800 Level Accessible Route of Travel and Accessible Signage

Project:
LEVI STADIUM ACCESSIBILITY

Sheet Description:
800 LEVEL ACCESSIBLE ROUTE OF TRAVEL AND ACCESSIBLE SIGNAGE

Sheet:
EXHIBIT D-8

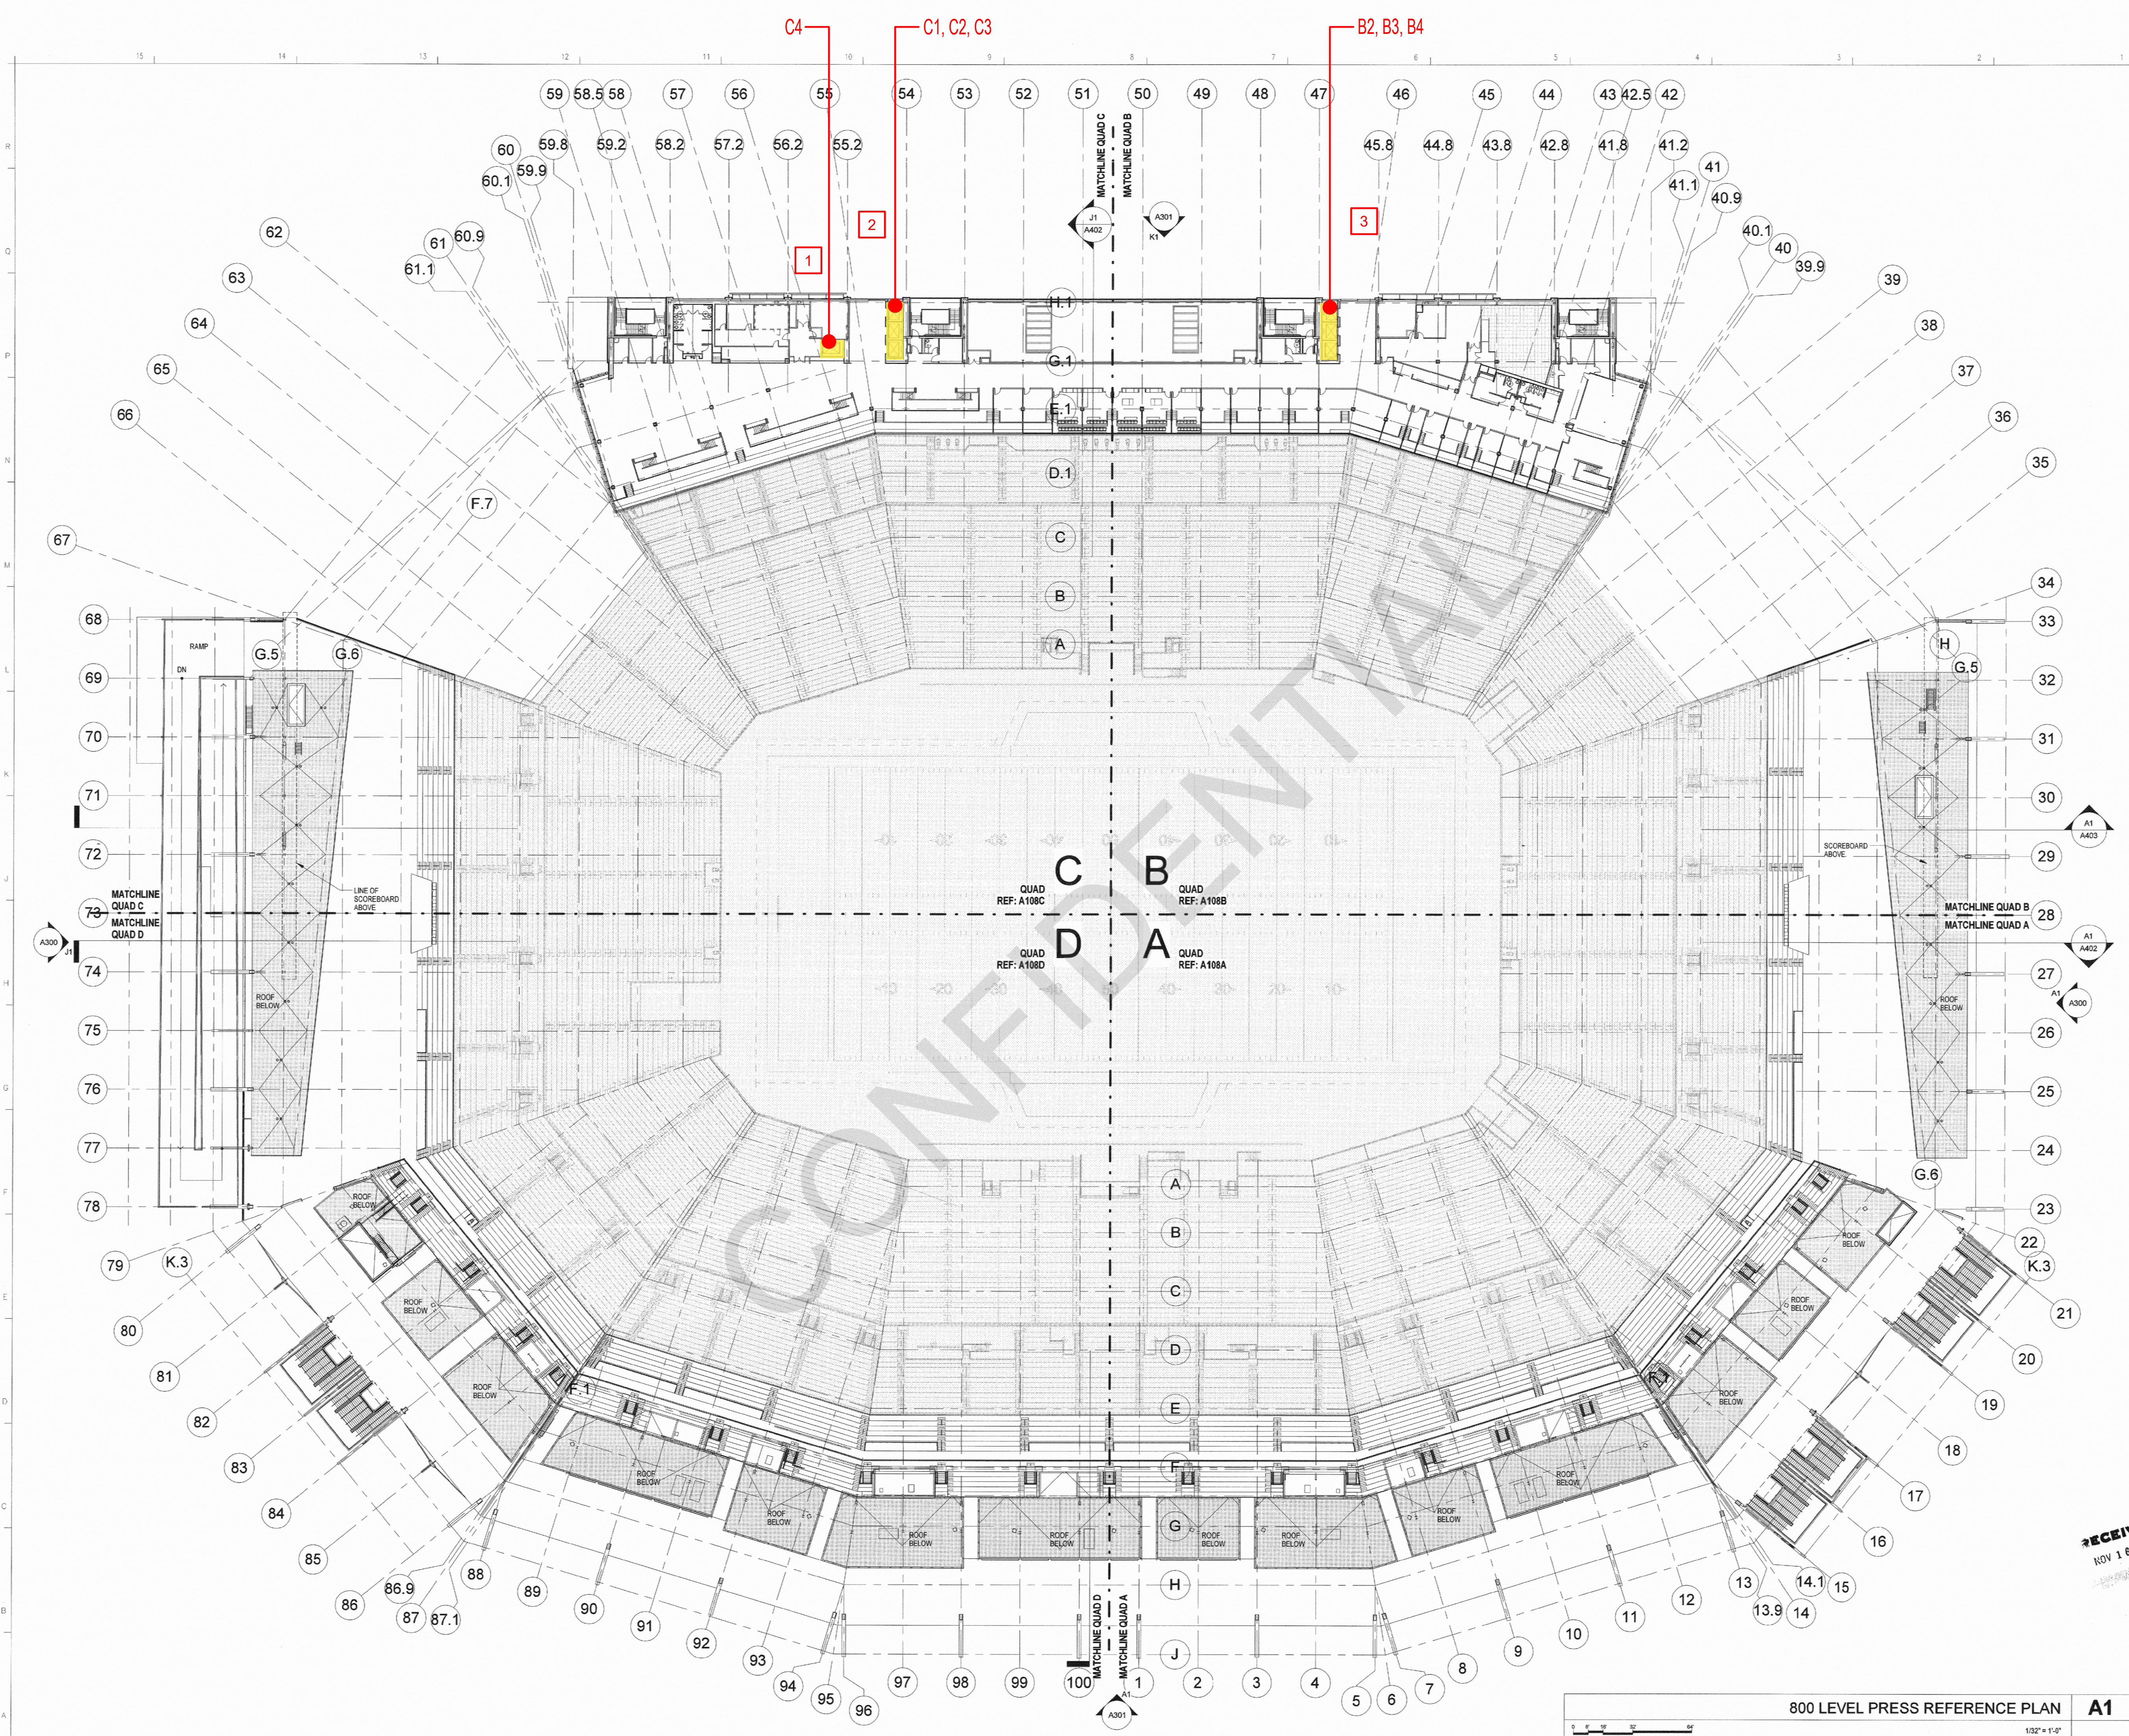
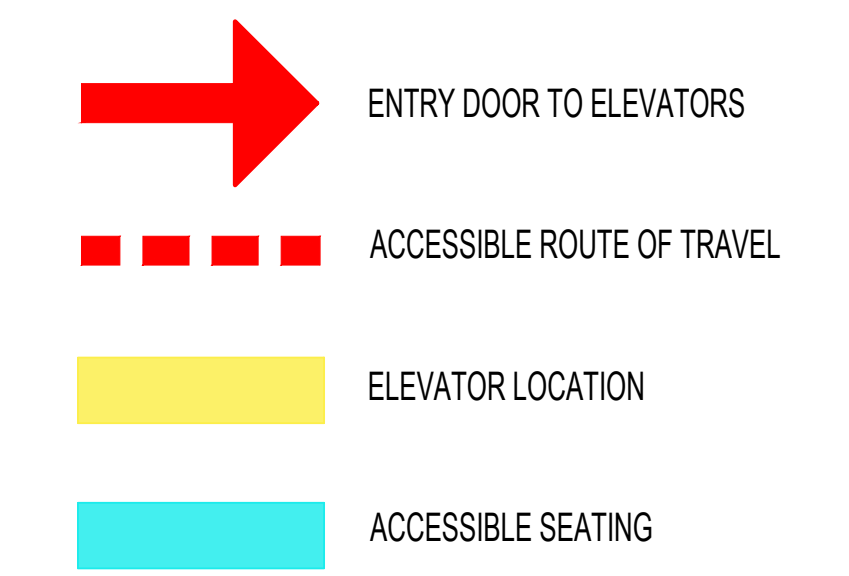
- 1 AT THE APPROACH TO ELEVATORS C1, C2, & C3 PROVIDE SIGNAGE AT A LOCATION CLEARLY VISIBLE TO PERSONS WITH DISABILITIES USING A WHEELCHAIR. THE LOCATION OF ELEVATOR C4 AND INDICATE IT SERVES THE NRG TERRACE. ALSO PROVIDE SIMILAR SIGNAGE AT THE DOOR LEADING TO THE LOBBY OF ELEVATOR C4.
- 2 AT ELEVATORS C1, C2 & C3 PROVIDE SIGNAGE AT A LOCATION CLEARLY VISIBLE TO PERSONS WITH DISABILITIES USING A WHEELCHAIR AND INDICATING THE STADIUM LEVELS THEY SERVE.
- 3 AT ELEVATORS B2, B3 & B4 PROVIDE SIGNAGE AT A LOCATION CLEARLY VISIBLE TO PERSONS WITH DISABILITIES USING A WHEELCHAIR AND INDICATING THE STADIUM LEVELS THEY SERVE. SIGNAGE SHALL ALSO INDICATE THE ELEVATOR B2 SERVES THE NRG TERRACE.
